IREDELL COUNTY HEALTH DEPARTMENT

IMPROVEMENT PERMIT / AUTHORIZATION TO CONSTRUCT / OPERATION PERMIT / EXISTING SYSTEM INSPECTION

PERMIT# 147980 PIN# 4638070921.000 DATE 8/13/08

INITIAL SITE SKETCH

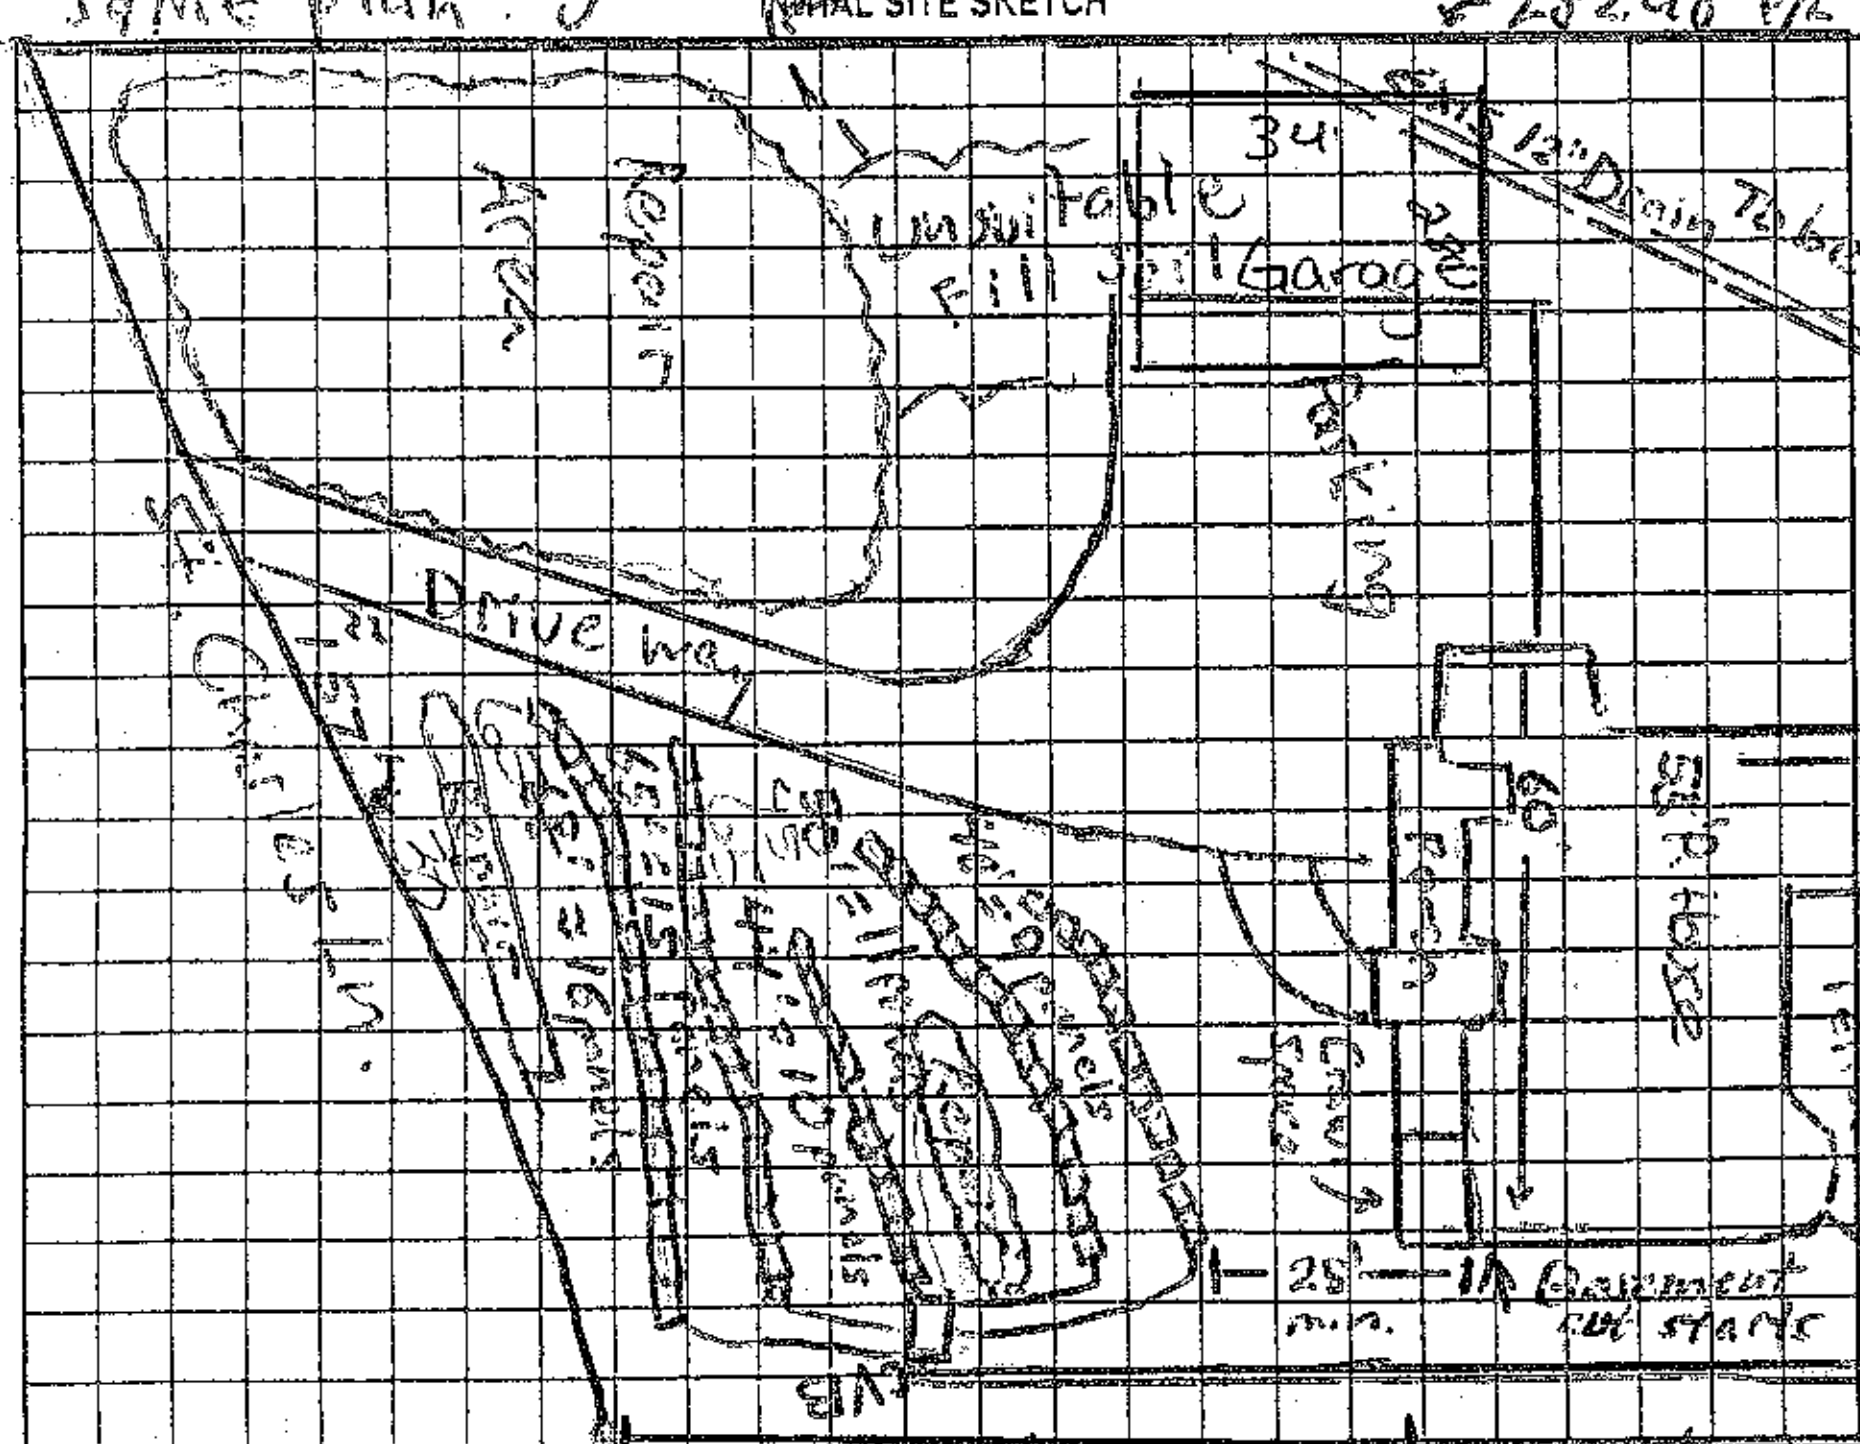
Comments:/Conditions: * Maintain 25' min separation of Septic from cut of basement. * Exis drain to be relocated away from well area. (* See Attached SAME plan.)

Comments:/Conditions: * Use existing driveway, Buildup/Fill Driveway to be even with ends of drainlines. Do not fill in drainfield Area. * Fence off Septic areas during Construction. * Main floor office must have cased doorway w/ O.P.

AS BUILT SKETCH

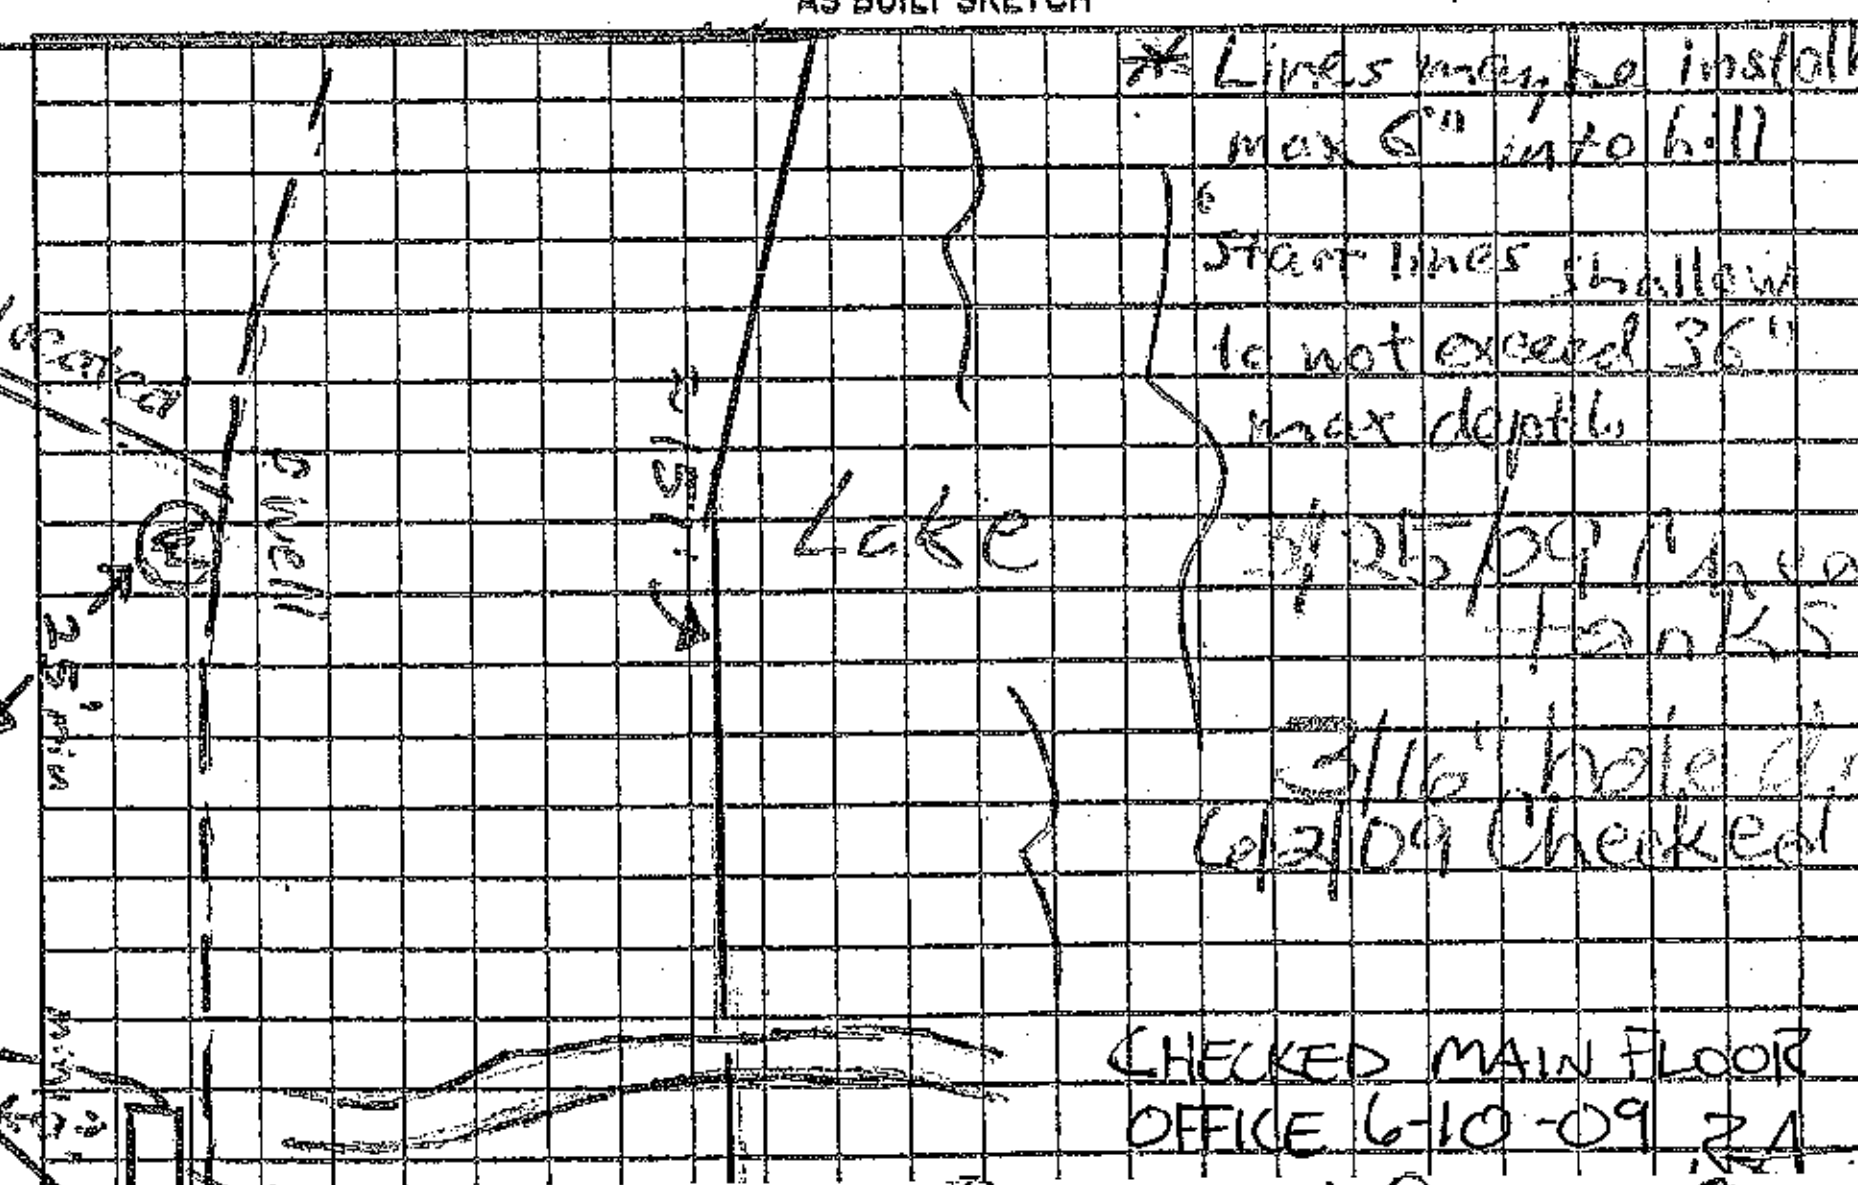
The proposed / existing Detached Garage addition does not appear to impact the existing septic system.
**NOTE:
[signature] Maria Dotson REHS
Date: 9/2/2010
ICHD-Environmental Health Division
